ADDENDUM NO.2

Westford Road Water and Sewer Replacement
Project No. 22DPW08
Ayer DPW

3 SANITARY SEWER MANHOLE AND PIPE ABANDONMENT

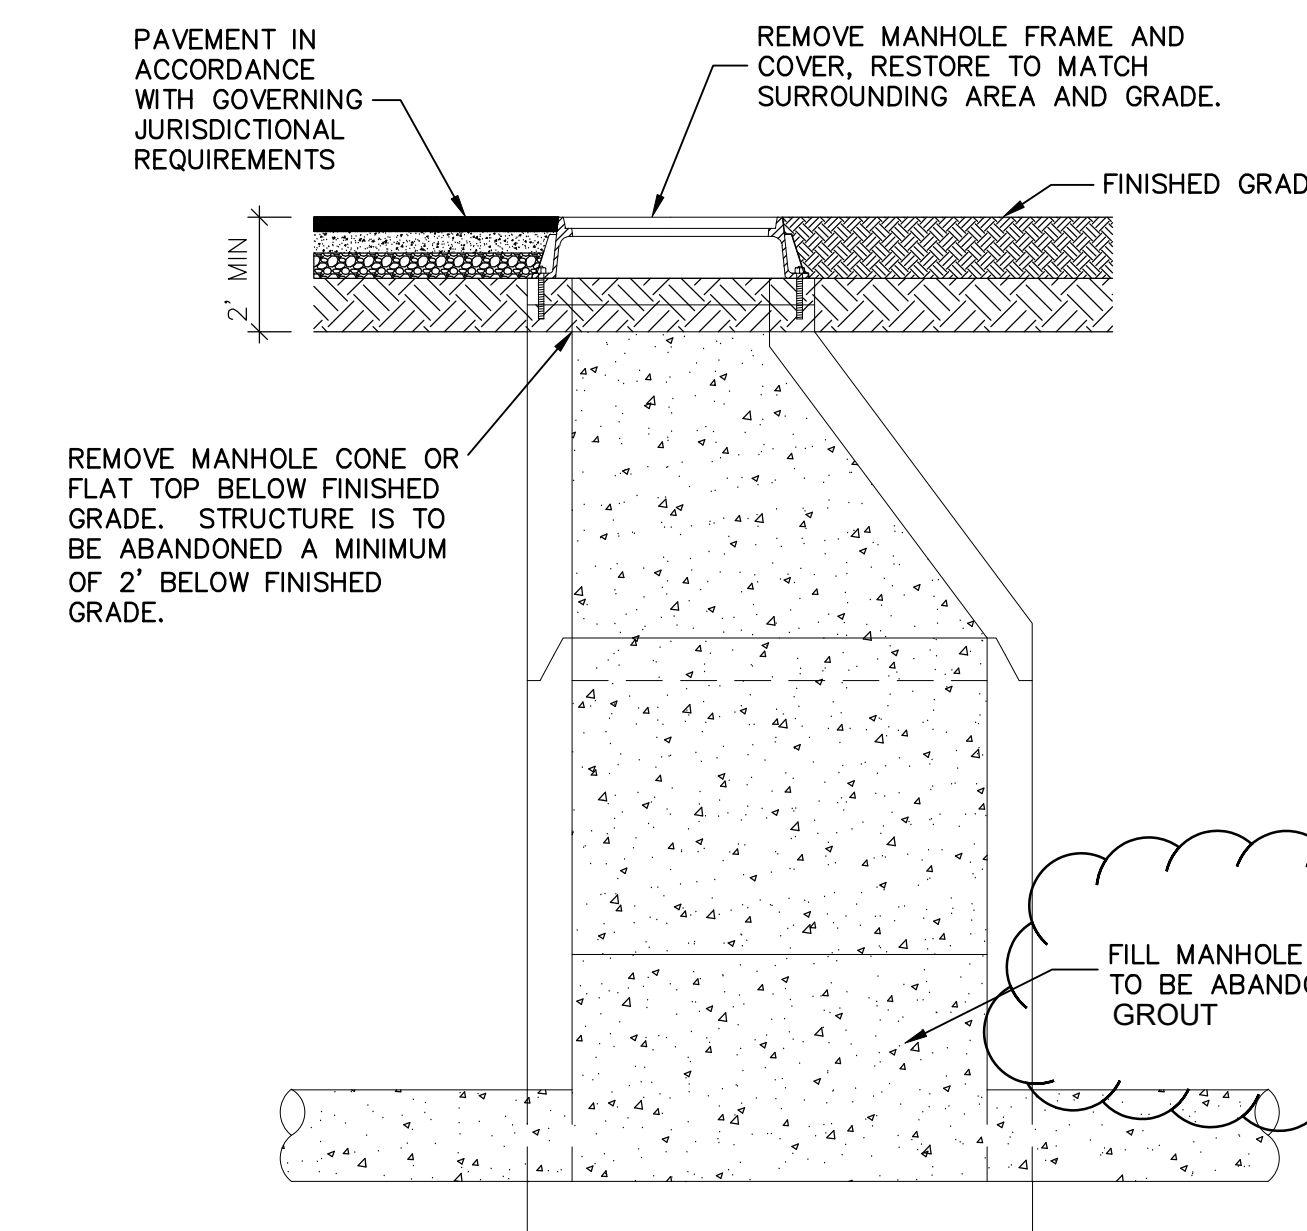
1. **Replace Drawing C-4 Details 2 in its entirety with the attached C-4A Details 2.**
The drawing was updated to change Detail C-3 Sanitary Sewer Manhole and Pipe Abandonment. Note was updated to read "FILL MANHOLE AND PIPES TO BE ABANDONED WITH GROUT".

3/1/2022	Revision to Detail 3	AEA	
NO.	DATE	ISSUED FOR	BY
